Addendum No. 02

SUBJECT: Willamette River: Stormwater Source Control Improvements Project
Lower Columbia River, Northeast Portland, Stadium Freeway
Multnomah
Grading, Drainage, Paving, Signing, Illumination, and Roadside Development
(Bids Closing April 30, 2026)

The following changes are made to the Project Plans:

SHEET NO.
BA04

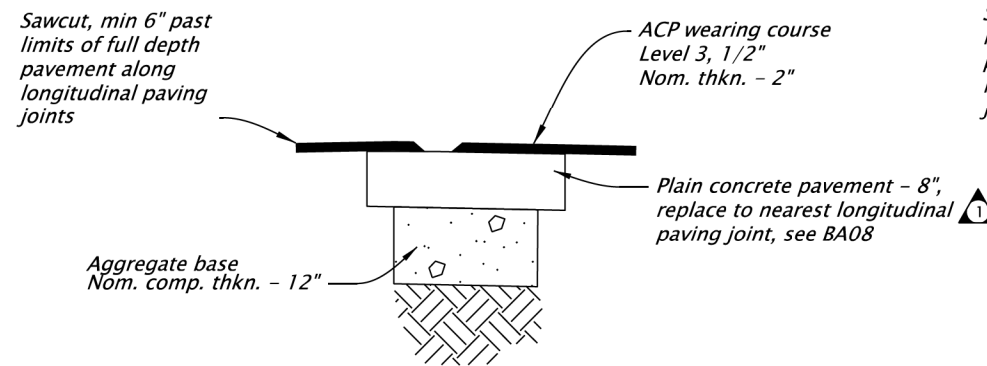
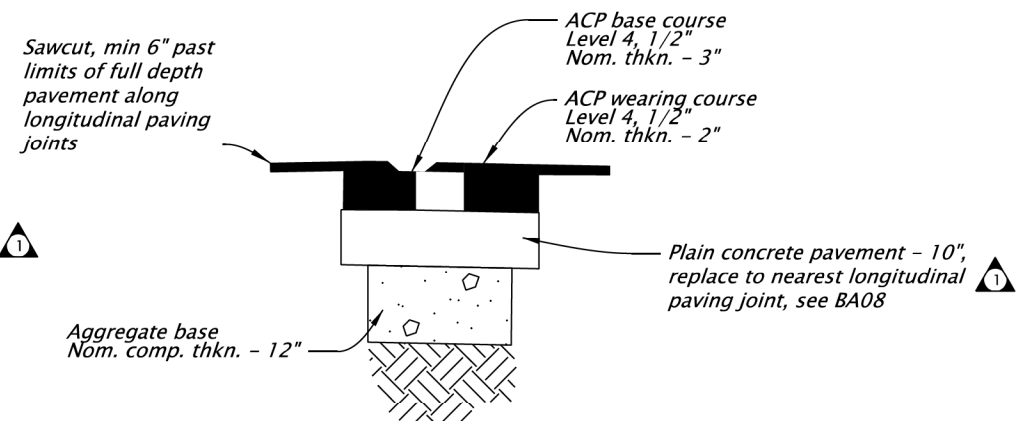
No.	DATE	REVISIONS	BY
1	04-14-26	Removed 'undowelled' from detail notes (2)	A.P.J.

WSP USA Inc. 1300 SW 5th Ave Suite 3100 Portland, OR 97201 Tel: 1 503 274 8772	
Designer: Alex Junge	Reviewer: Veronica Vong
Drafter: Grace Harrison	Checker: Veronica Vong
GENERAL CONSTRUCTION	
SHEET NO. C201

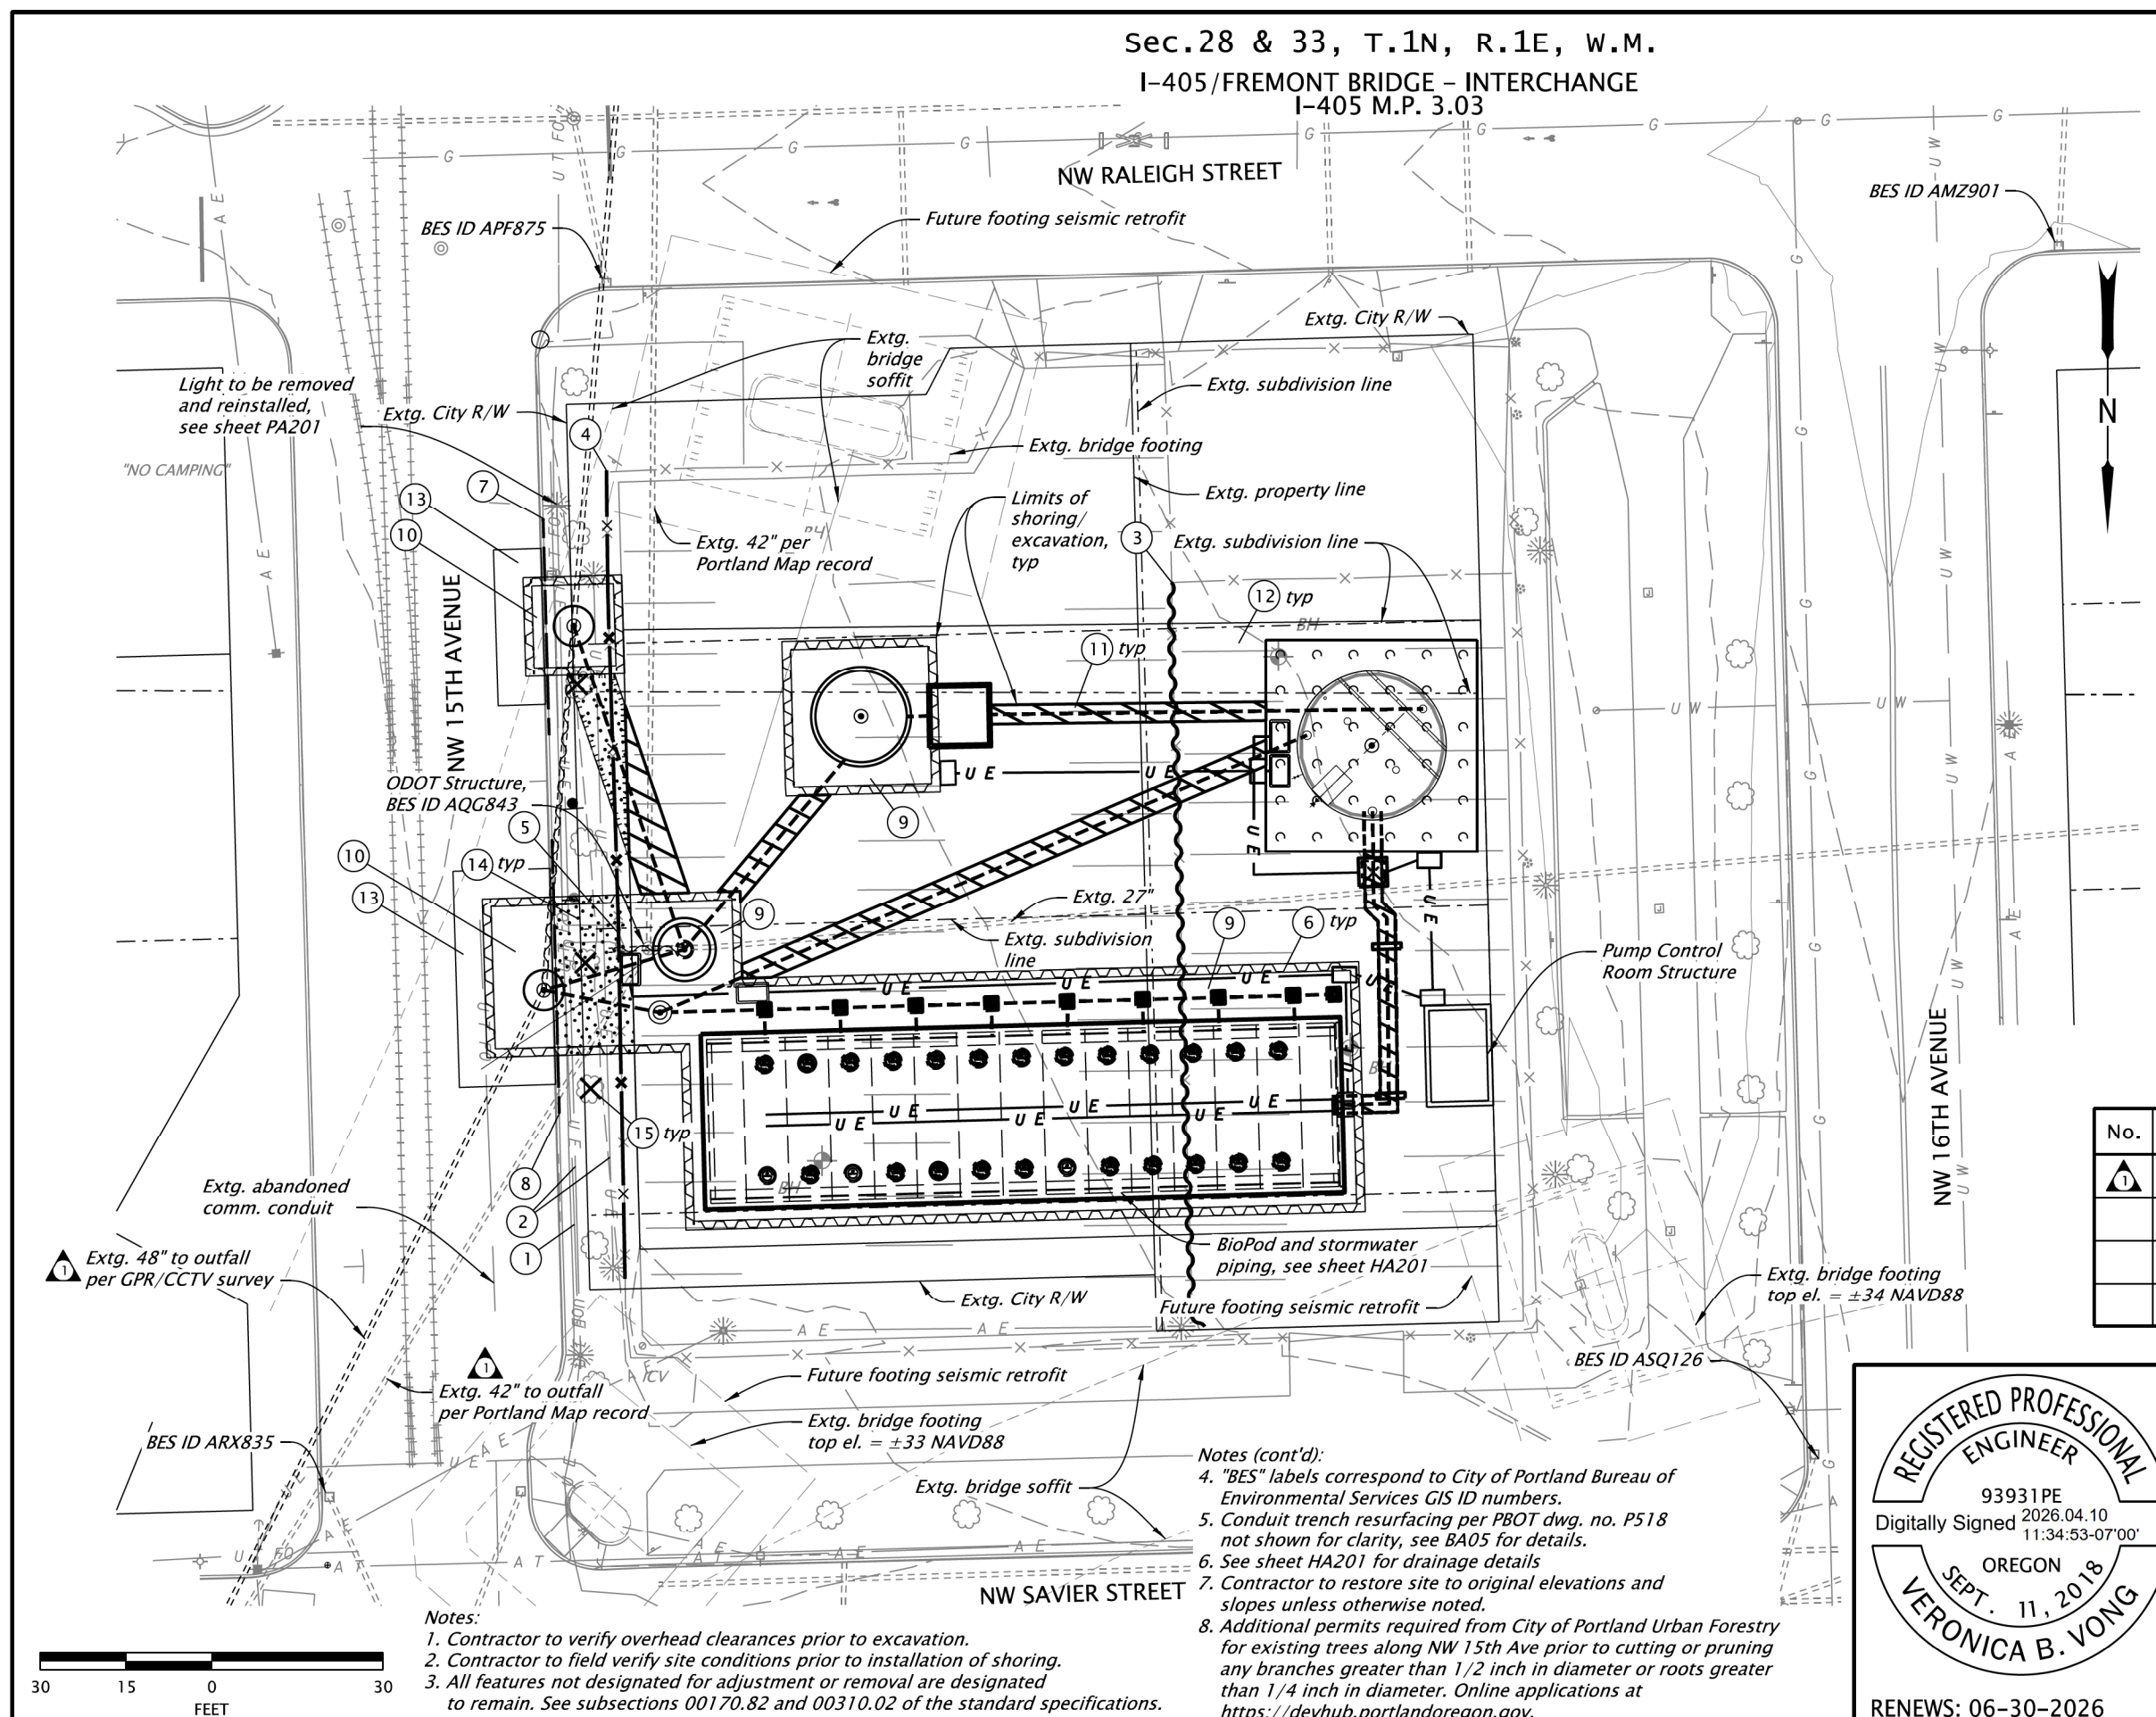
No.	DATE	REVISIONS	BY
1	04-10-26	Adjusted outfall pipe diameters to be consistent with surveys and HA sheets	A.P.J.

GENERAL CONSTRUCTION	SHEET NO. C581
-----------------------------	-------------------

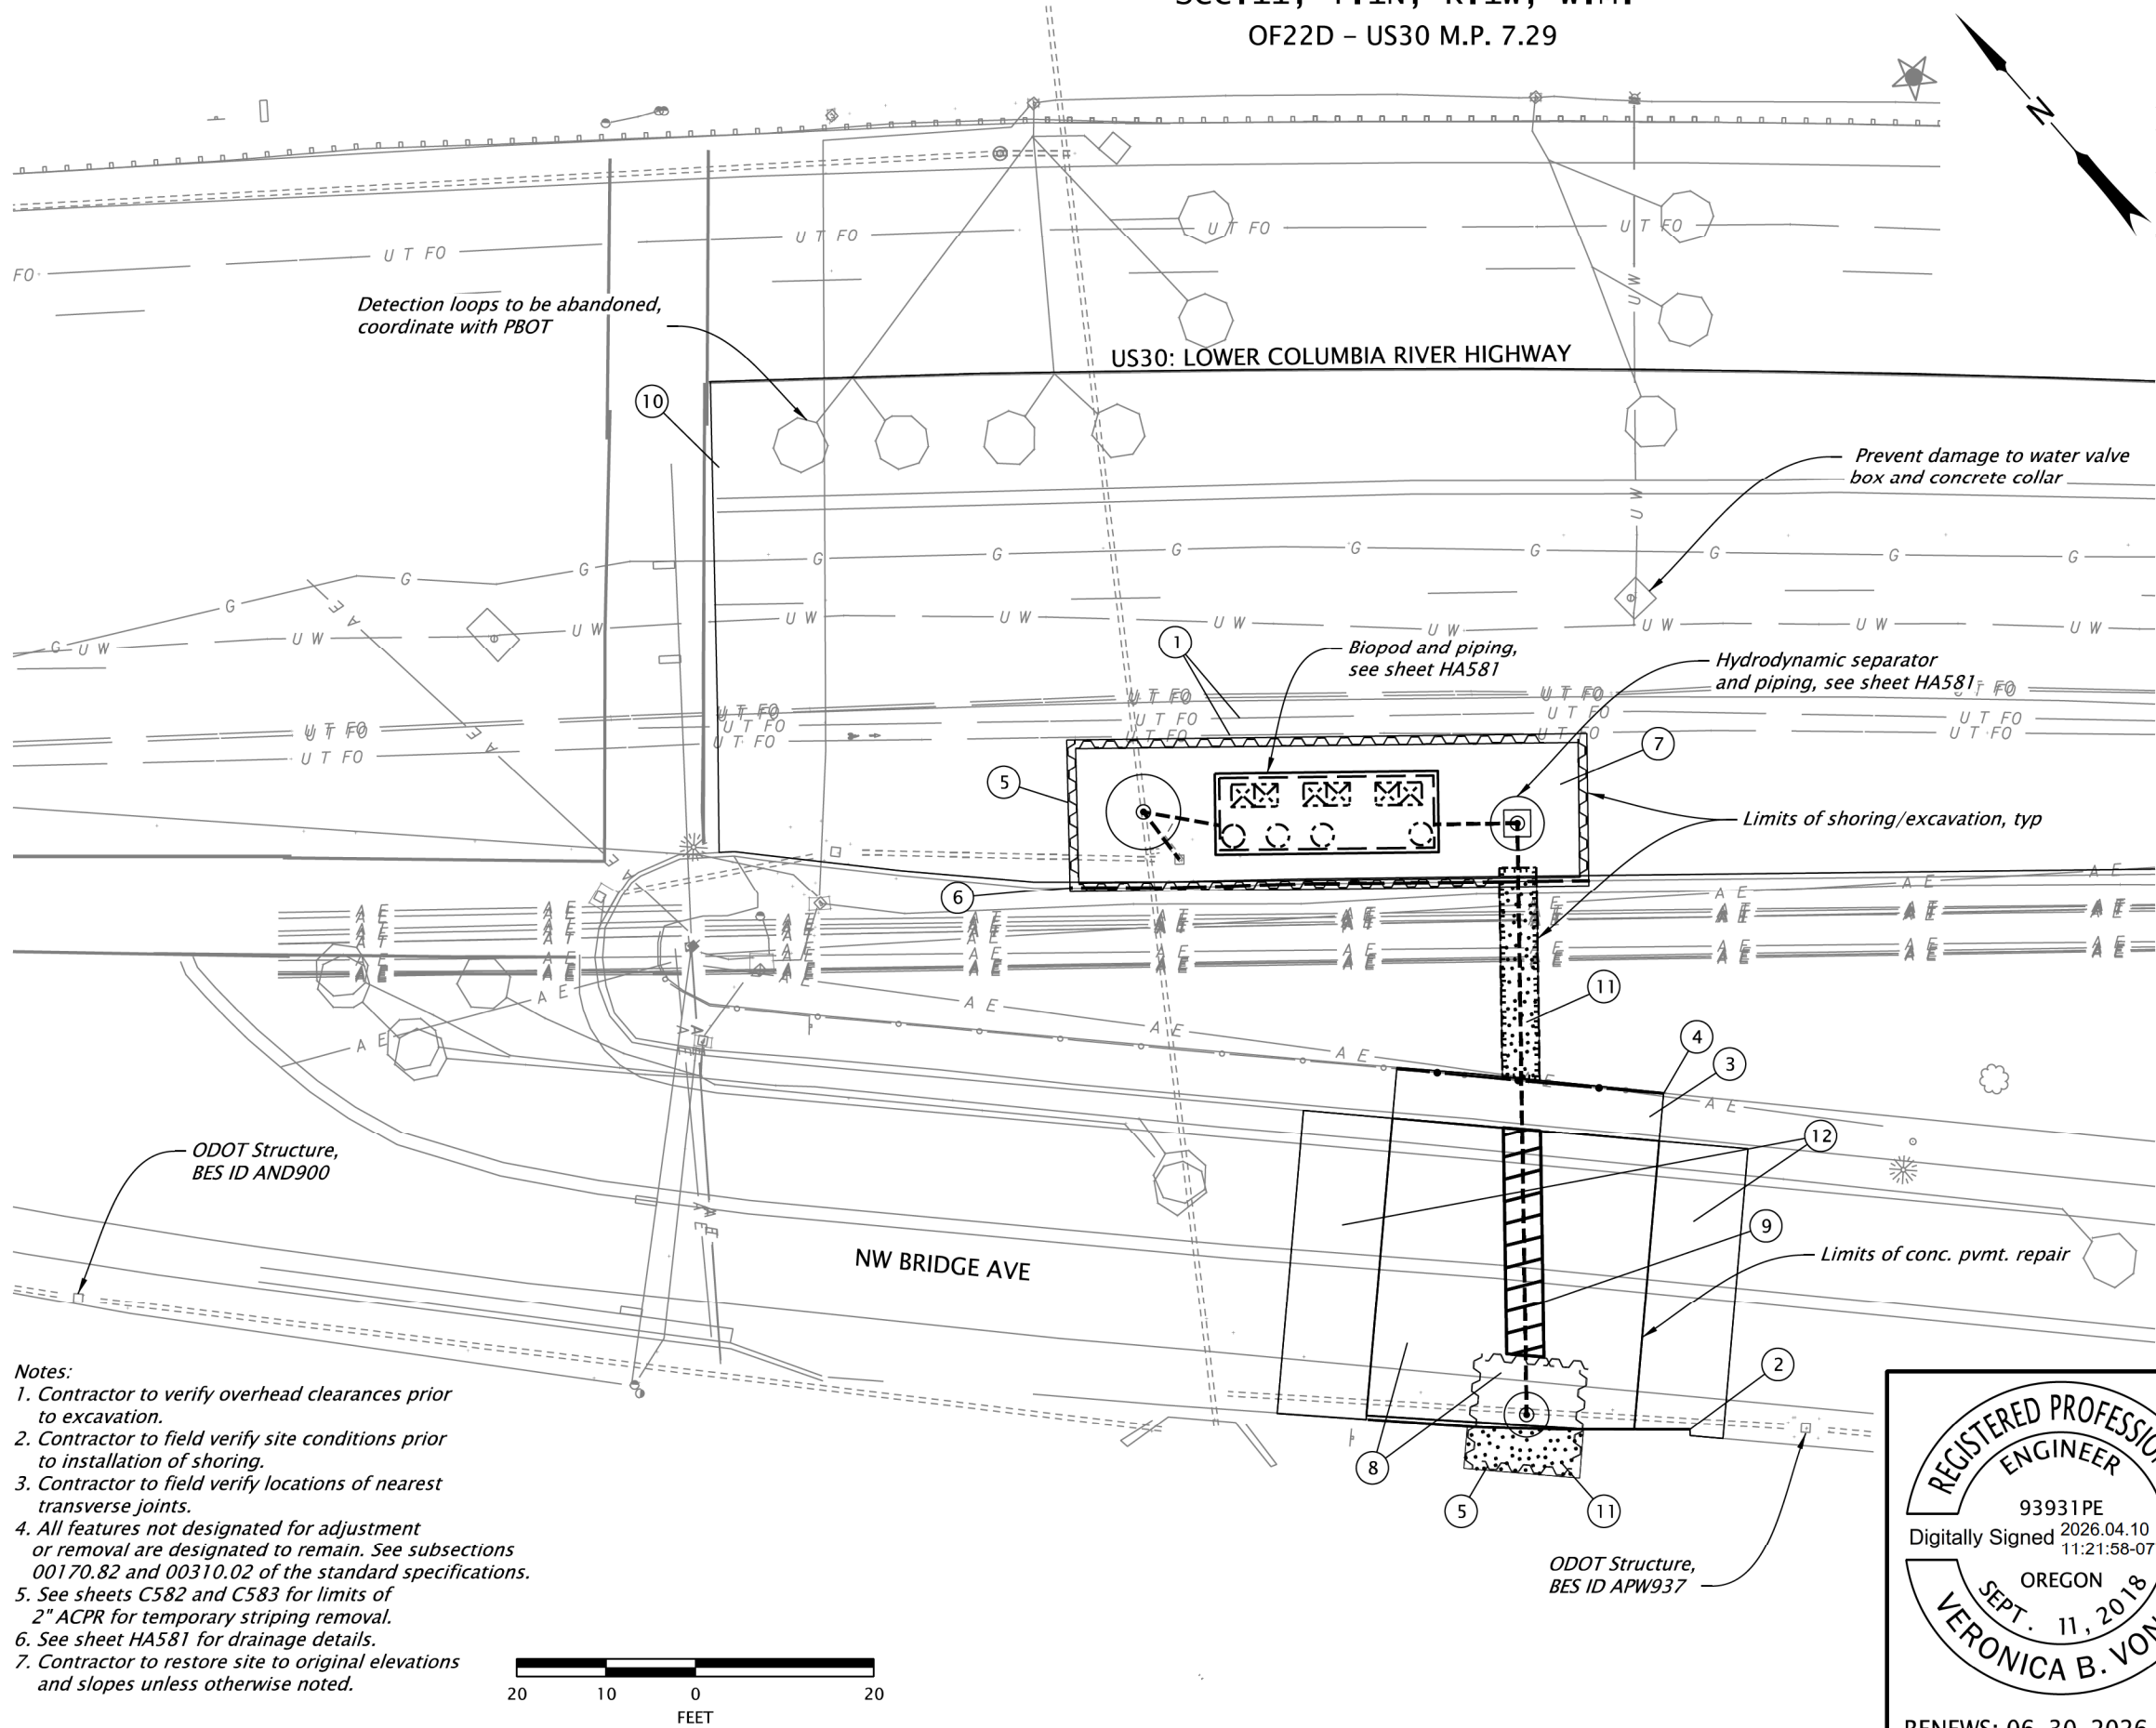
No.	DATE	REVISIONS	BY
①	04-09-26	Changed unit in note 9 - CUYD to SQYD	A.P.J.

SLAB ON GRADE AND PIPE SUPPORT DETAILS
SHEET NO. S401

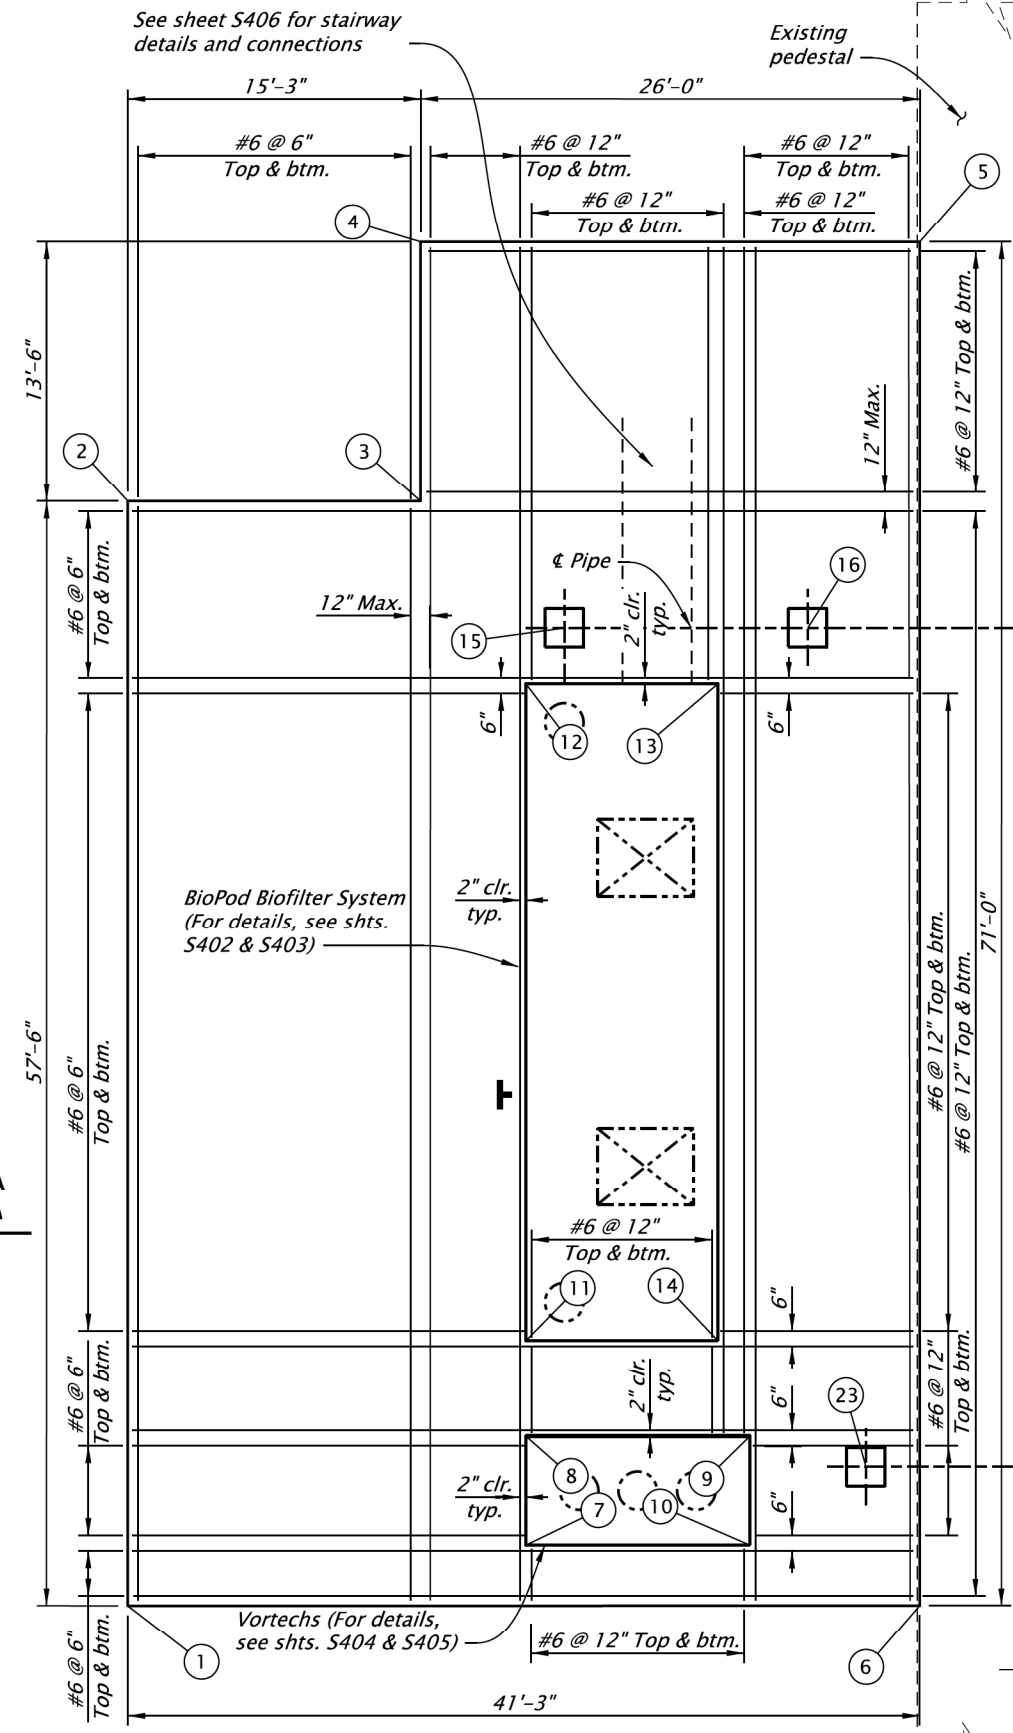
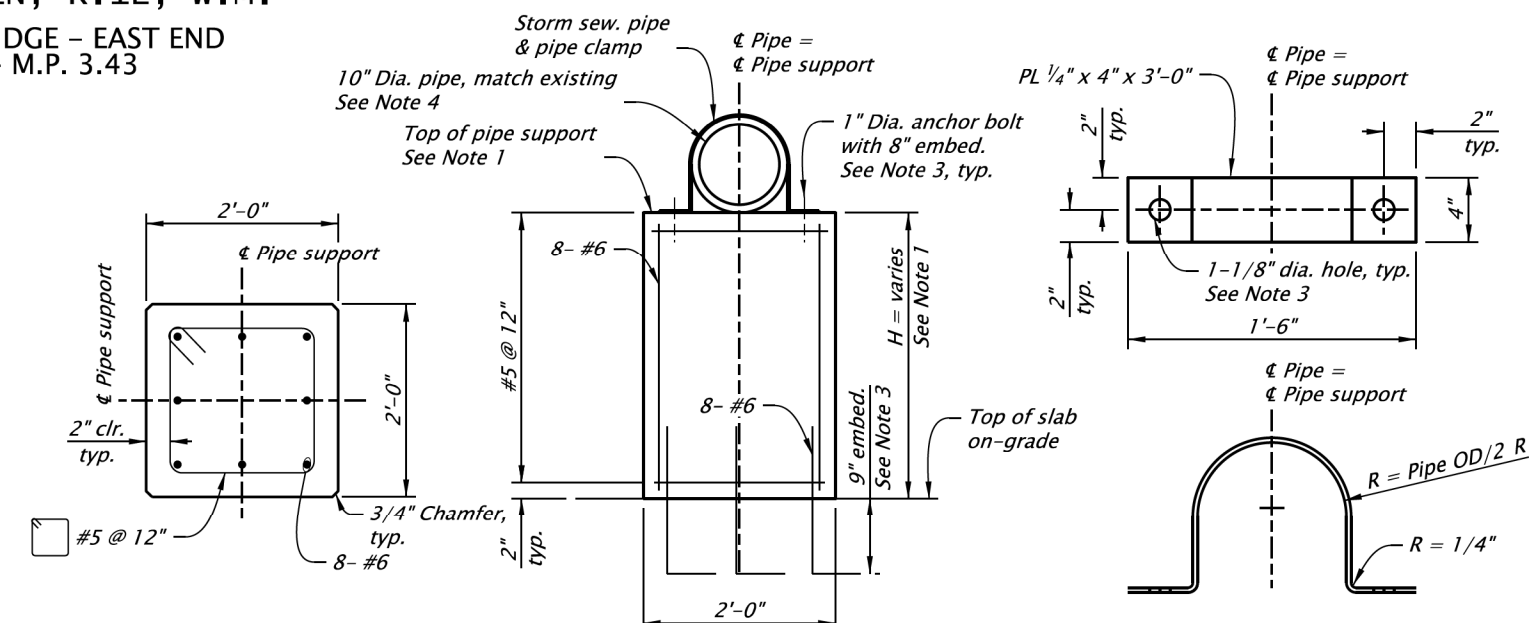
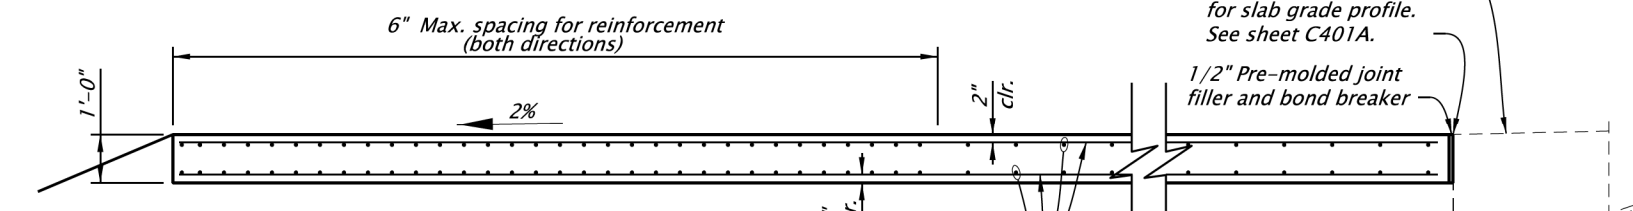
No.	DATE	REVISIONS	BY
1	04-10-26	Added notes 3 and 4.	A.P.J.

- Notes:**
- See HA401A for pipe profile. Adjust height of pipe support as required.
 - Stairway connection to slab not shown.
 - Contractor shall locate extg. reinforcement in pedestal by GPR or other approved methods prior to construction.
 - Contractor shall verify diameter of existing drainpipe prior to fabrication and construction.
